CALIFORNIA CENTRAL VALLEY
FLOOD CONTROL
 ASSOCIATION

October 30, 2015

Subject: CCVFCA Comments on the Partially Recirculated Bay-Delta Conservation Plan EIR/EIS with New CA WaterFix Sub-Alternatives

Figure 1. Projected Inflow to Trinity, Shasta, Oroville, and Folsom Reservoirs – NAA, NAA-ELT and NAA-LLT

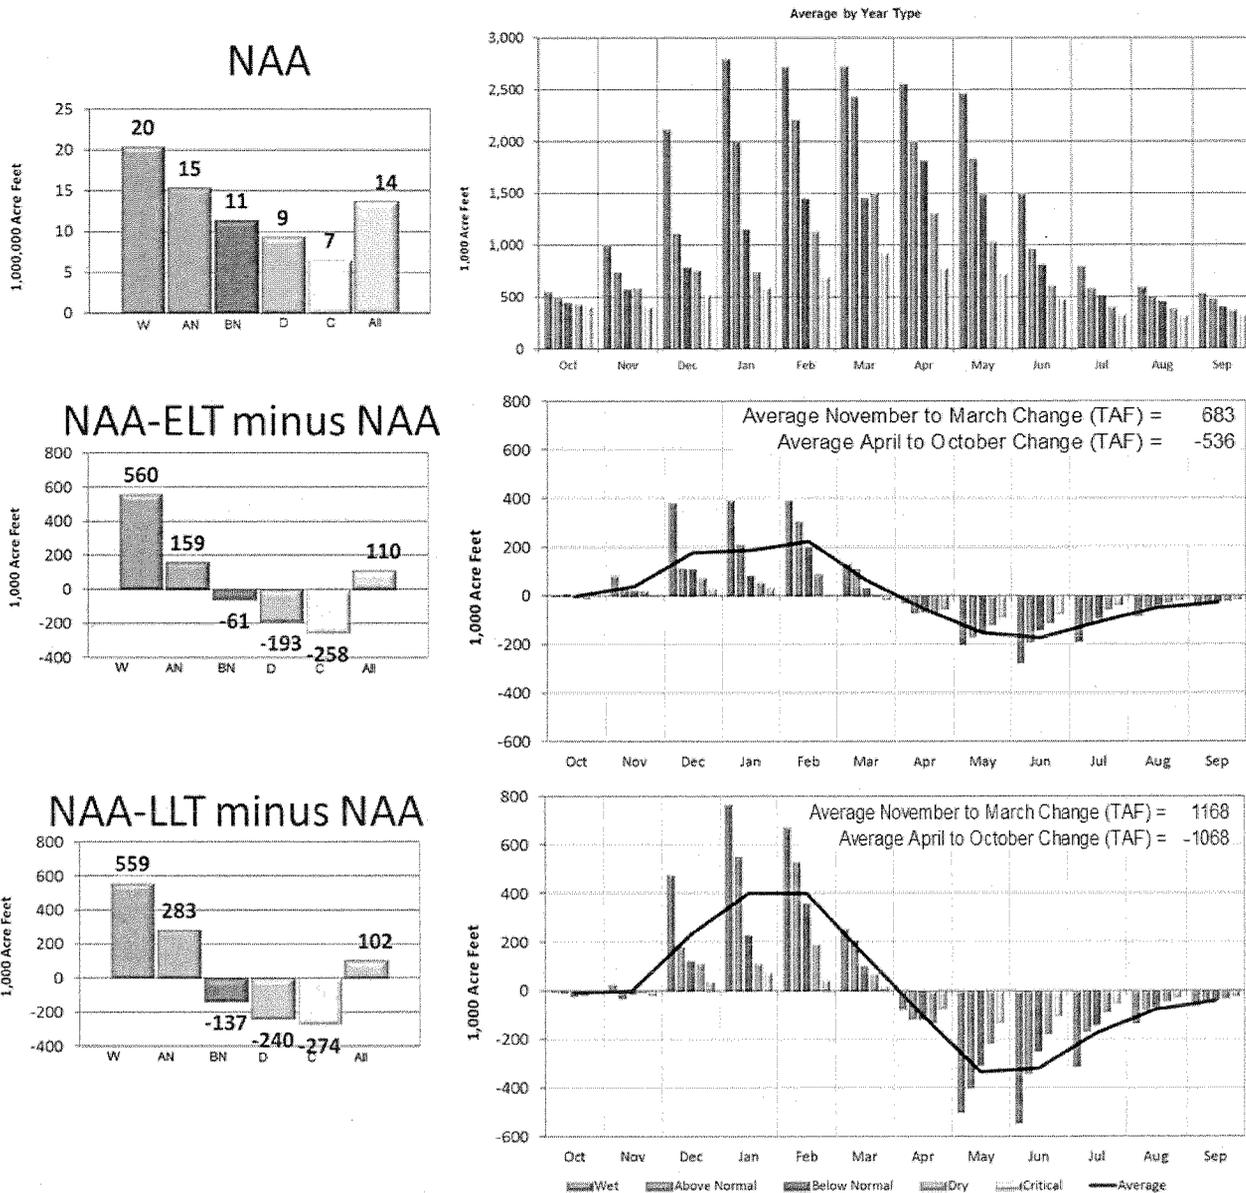
The significance of changed hydrology between the three without project baselines is illustrated in Figure 1 below. The figure illustrates the projected combined inflow of Trinity, Shasta, Oroville, and Folsom Reservoirs under the three NAA baselines. Numerous modeling projections for climate change have been developed, and in this BDCP group of Scenarios Trinity, Shasta, and Oroville inflow are projected to increase overall, but with a

In our opinion, the CalSim II depicted operations that incorporate climate change are not reasonably foreseeable and do not represent a likely future operation of the CVP/SWP. Although an argument is typically made that these study baselines will be used in a comparison analysis with Project Alternatives tiering from these baselines, we believe that the depicted operations do not represent credible CVP/SWP operations and we have no confidence in the results and they are inappropriate as the foundation of a Project Alternative. As such, although the modeling approach may provide a relative comparison between equal foundational operations, we are apprehensive to place much confidence in the computed differences shown between the NAA and Project Alternative Scenarios.

Figure 2. Projected Shasta Reservoir Carryover Storage, NAA, NAA-ELT and NAA-LLT

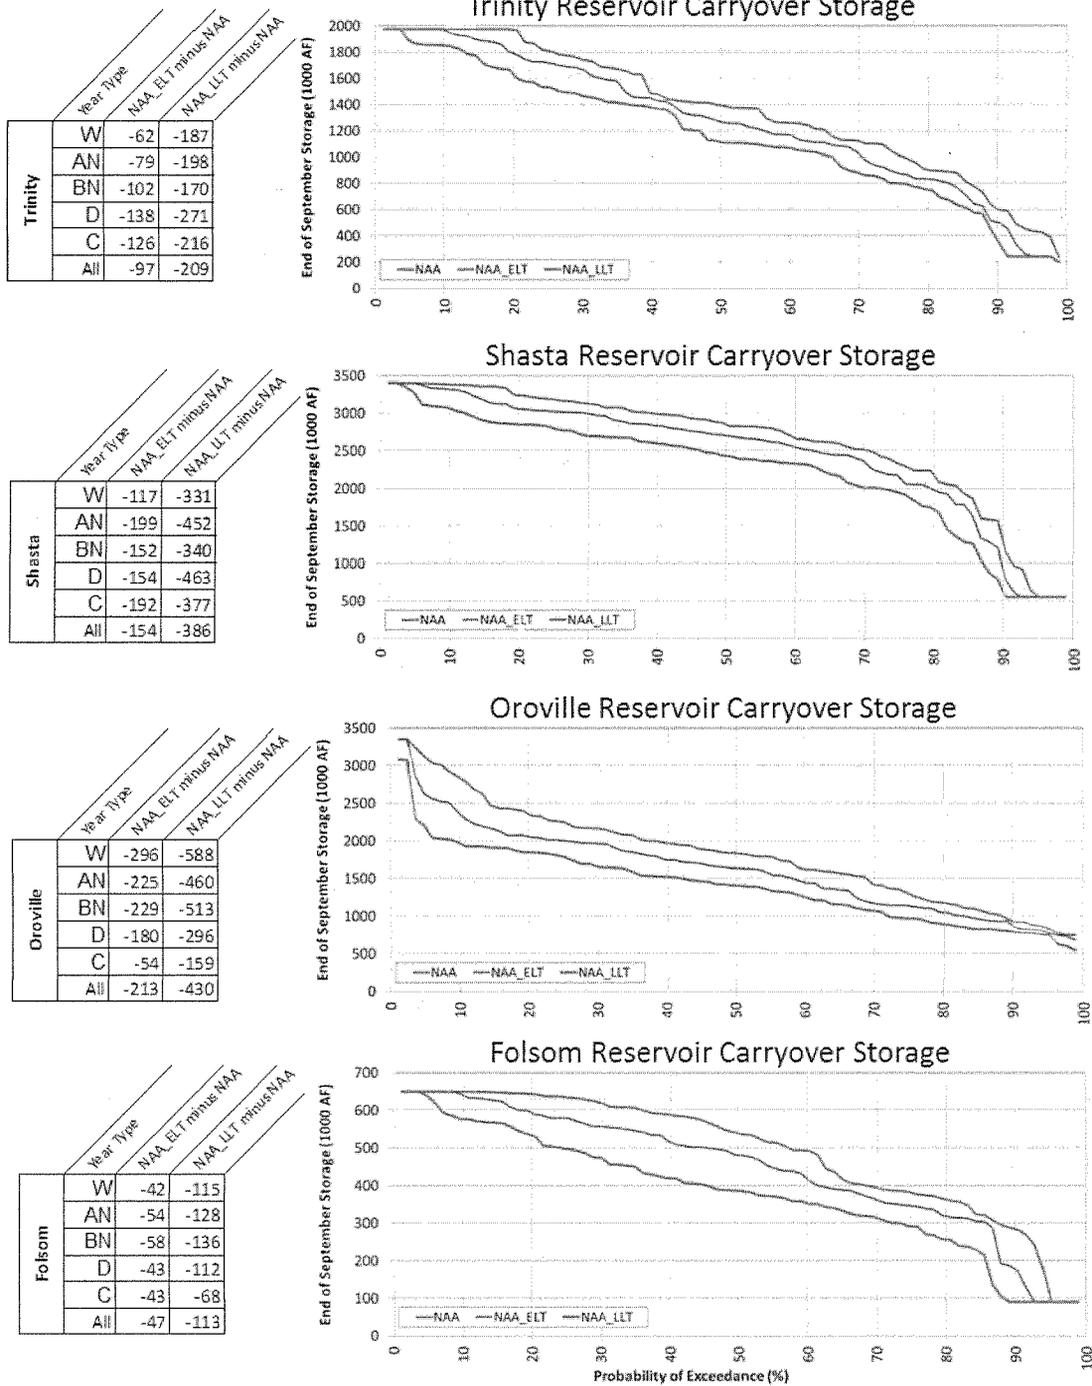
For upstream CVP and SWP reservoirs the assumed shift of inflows due to climate change (Figure 1) along with a continuing need to satisfy exports demands significantly affects carryover storage. The CVP and SWP simply cannot satisfy water demands and regulatory criteria imposed on them in the NAA-ELT and NAA-LLT modeling scenarios.

Figure 2 illustrates the typical change in carryover storage as shown for Trinity, Shasta, Oroville, and Folsom Reservoirs. The relatively high frequency (approximately 10% of time) of minimum storage occurring at CVP reservoirs illustrates our questioning of credible operations in the studies.

Figure 3. Projected Inflow to Millerton Lake –NAA, NAA-ELT and NAA-LLT

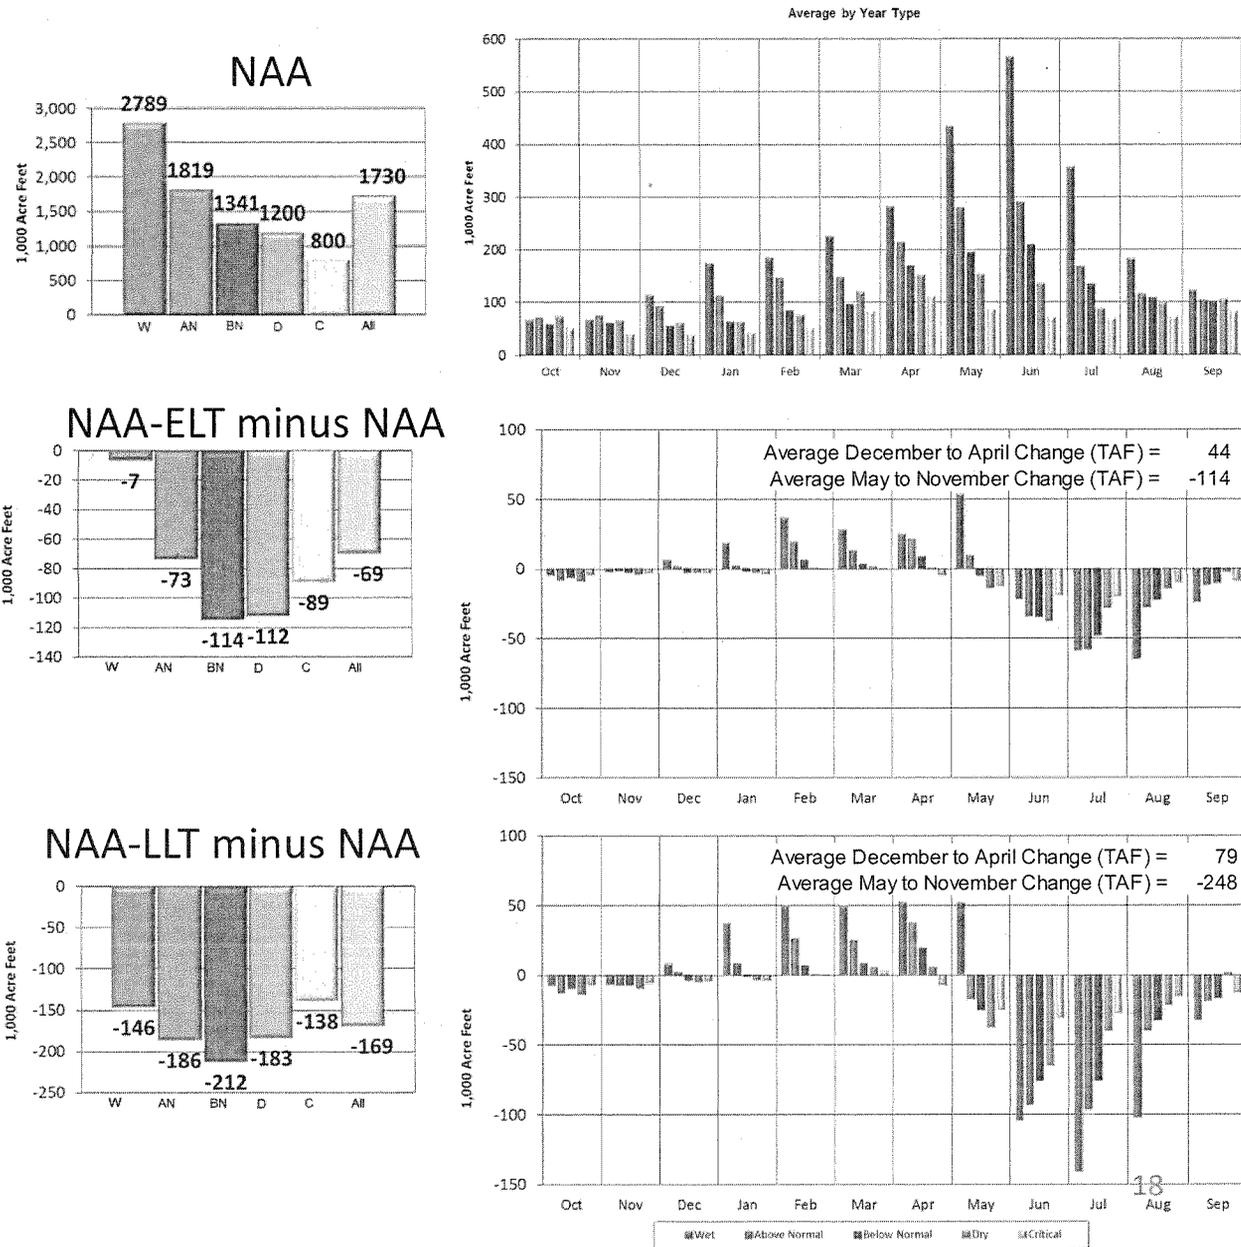
San Joaquin Valley reservoirs are depicted with an overall decrease in annual runoff with some shifting of runoff from spring to winter, but mostly just decreases in spring runoff due to a decline in snowmelt runoff during late spring⁵. Figure 3 illustrates the assumed effects of climate change upon inflow to Millerton Lake.

The hydrology differences imposed in the NAA Scenarios of the Friant Division are described above, and its appropriateness may be subject to additional debate and Alternative assumptions. However, our review found that implementation of Millerton Reservoir inflow as affected by climate change was improperly performed.

Inflow to Millerton Reservoir in this version of CalSim is input in three separate time series for purposes of depicting the hydrology of potential upper basin reservoirs. Climate change hydrology was inconsistently incorporated at Millerton Reservoir and misapplied to the water supply and flood control operations. The result is an unrealistic operation for river releases and canal diversions. Figure 3 illustrates the projected ELT and LLT changes in Millerton Reservoir inflow incorporated in these studies. On face value of the input data, regardless of Friant Dam river release assumptions the effect of climate change at Millerton Lake will affect water deliveries.

Figure 12. Temperature Exceedance Sacramento River at Bend Bridge Existing, No Action Alternative, ELT

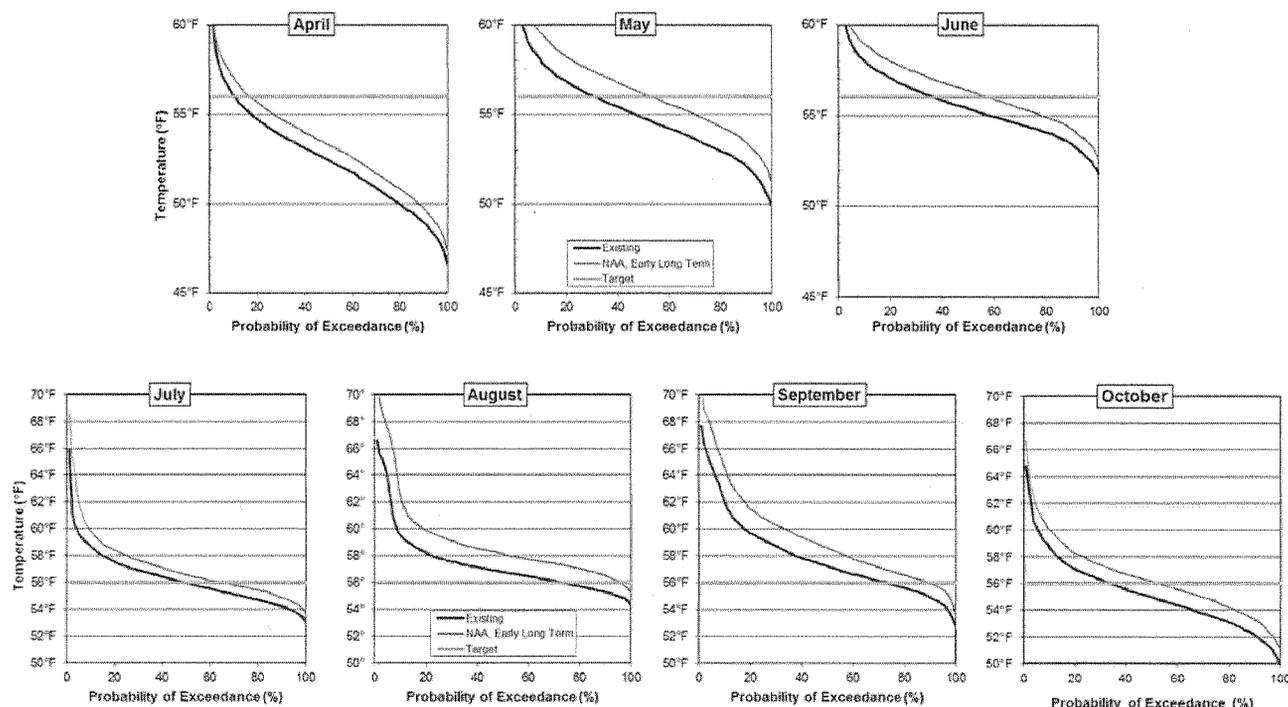
The increase in equilibrium temperatures combined with decreases in storage would lead to water temperature conditions that would likely not achieve the assumed objectives. Figure 12 and Figure 13 illustrate an increase in the probability that a water temperature target of 56°F would be exceeded at Bend Bridge under both the NAA-ELT and NAA-LLT Scenarios. The probability of exceedance increases approximately 5% to 20% depending on the month for the NAA-ELT Scenario and approximately 10% to 40% for the NAA-LLT Scenario.

Figure 19. NDD, Bypass Requirement, Bypass Flow, and Excess Sacramento R. flow for Alt 4-ELT

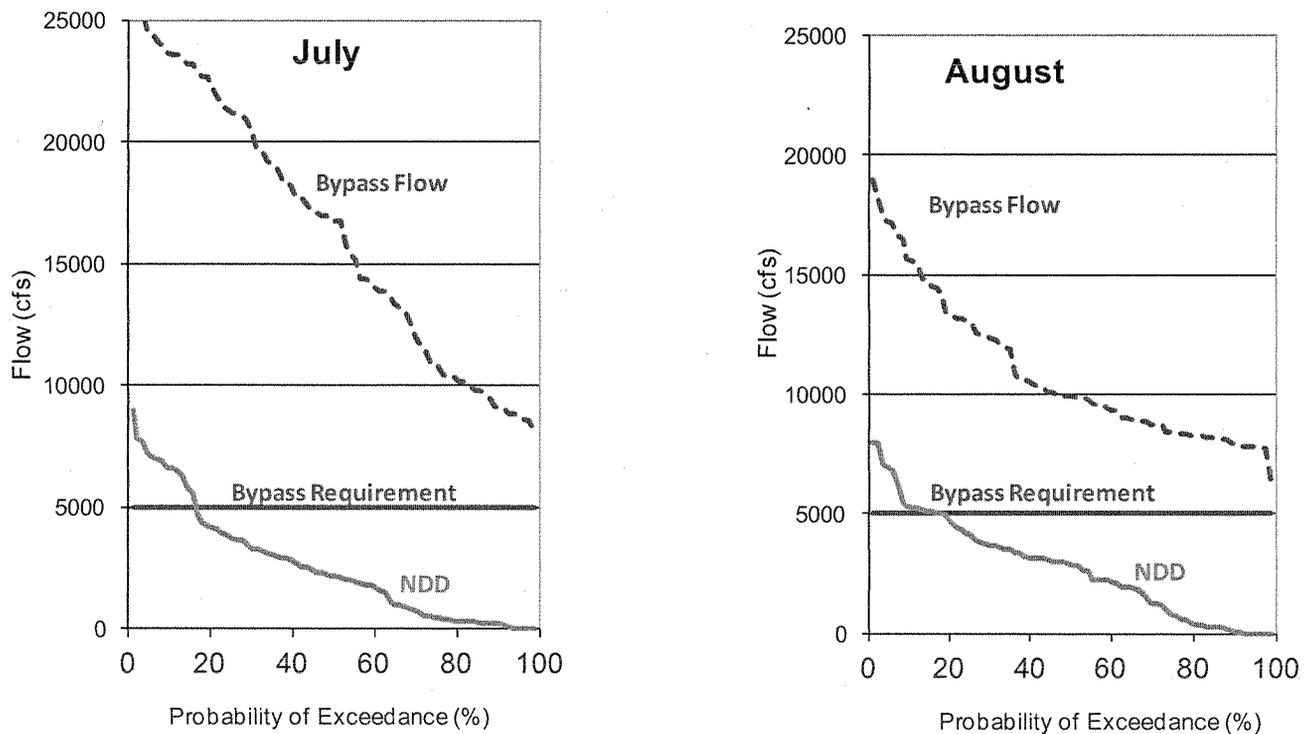
Sacramento River flow below the North Delta Diversion (NDD) must be maintained above the specified bypass flow requirement, therefore the NDD rates are limited to the Sacramento River flow above the bypass requirement. Due to an error in CalSim II that specifies an unintended additional bypass requirement, modeling performed for the BDCP EIRS often bypasses more Sacramento River flow than is specified in the BDCP project description. This error has been fixed in the most recent public releases of CalSim II, but BDCP modeling has not been updated to reflect these fixes. Figure 19 contains exceedance probability plots showing the Sacramento River required bypass, Sacramento River bypass flow, NDD, and excess Sacramento River flow to the Delta as modeling for BDCP. As can be seen in Figure 19, the bypass flow is always above the bypass requirement in July and August. The BDCP version of CalSim sets a requirement for Sacramento River inflow to the Delta needed to satisfy all Delta flow, quality, and export requirements, this requirement should be removed when modeling the NDD.

Figure 20. Change in CVP (Jones) and SWP (Banks) Exports (Alt 4-ELT minus NAA-ELT)

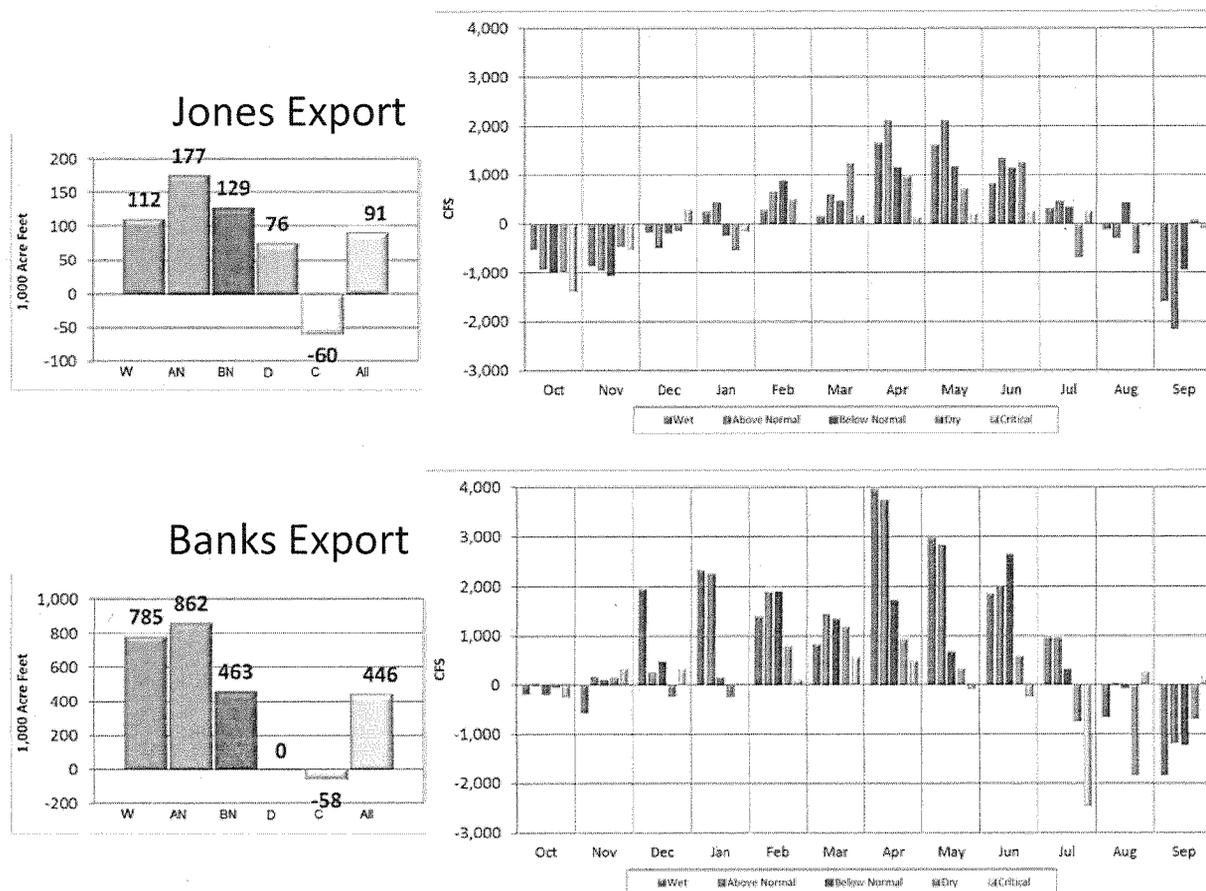
Overall the Alt 4 will increase exports compared to the NAA-ELT, with the majority of the increased exports realized by the SWP. Figure 20 illustrates a comparison between the NAA-ELT and Alt 4-ELT of CVP and SWP exports. On average, total combined exports under Alt 4-ELT are projected to increase by 537 TAF from 4.73 MAF to 5.26 MAF compared to the NAA-ELT.

Figure 21. Change in Conveyance Source of Exports (Alt 4-ELT minus NAA-ELT)

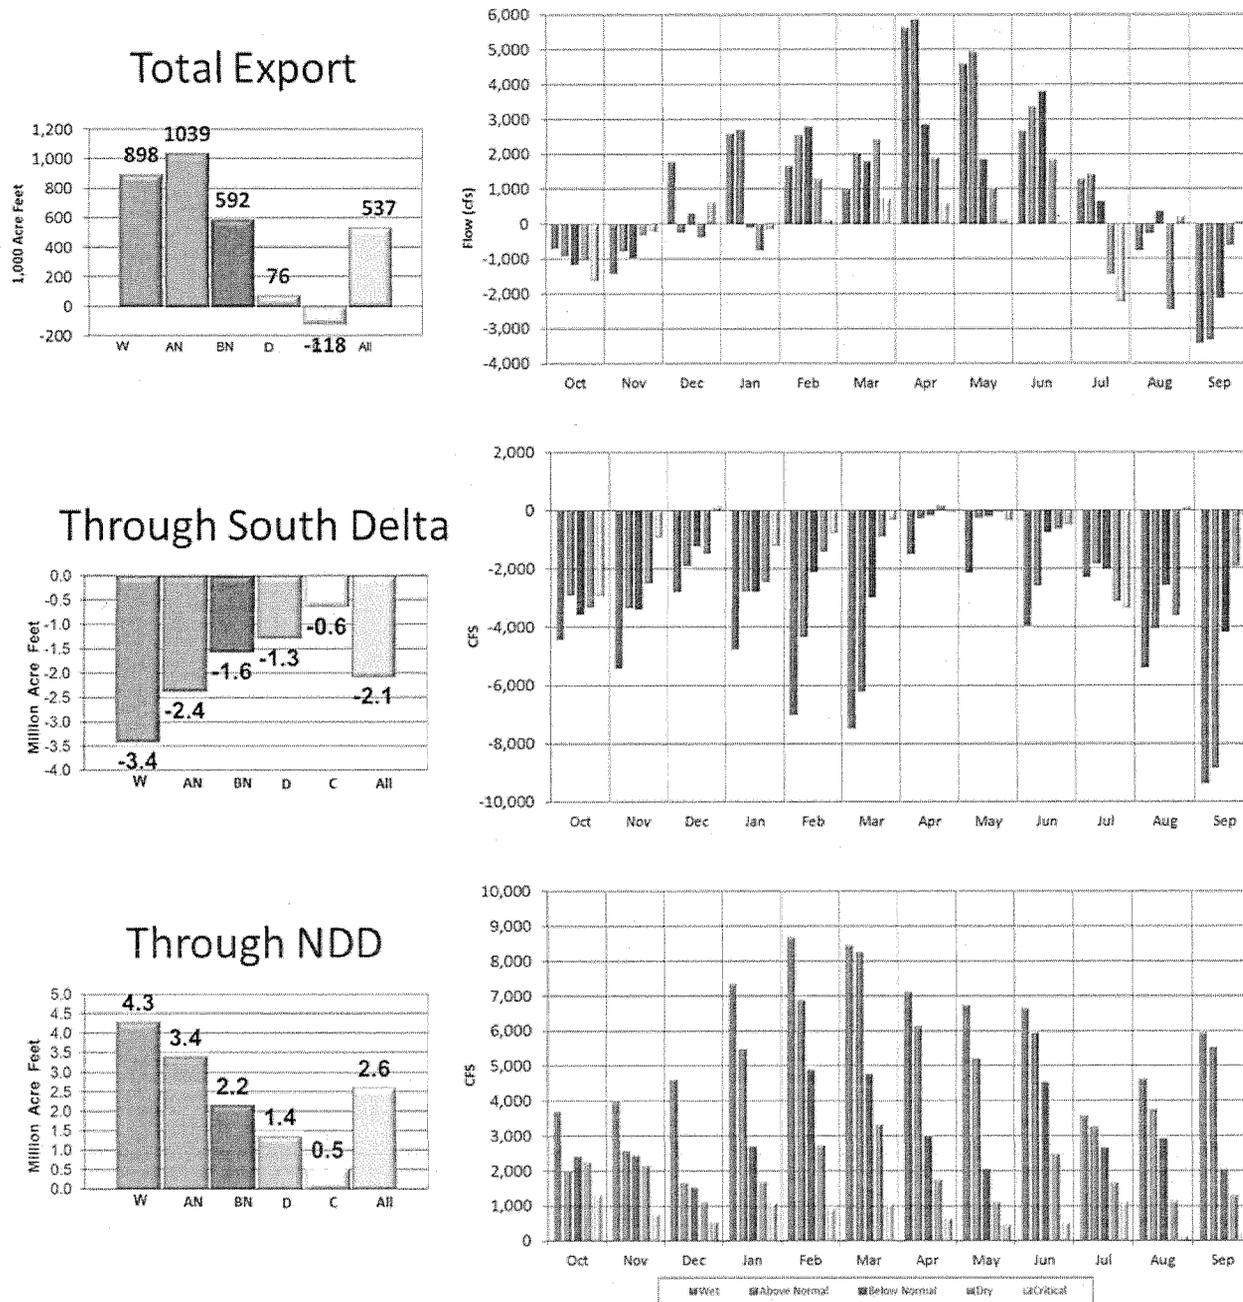
With the addition of the North Delta Diversion facility, the water exported dramatically shifts from South Delta diversions to North Delta diversions. Figure 21 illustrates the change in routing of South of Delta exports under Alt 4 compared to the NAA-ELT. On average, export through the South Delta facility are projected to decrease by 2.1 MAF and the North Delta diversions will export 2.6 MAF which includes the 2.1 MAF shifted from the South Delta facility plus the additional 537 TAF of increased exports.
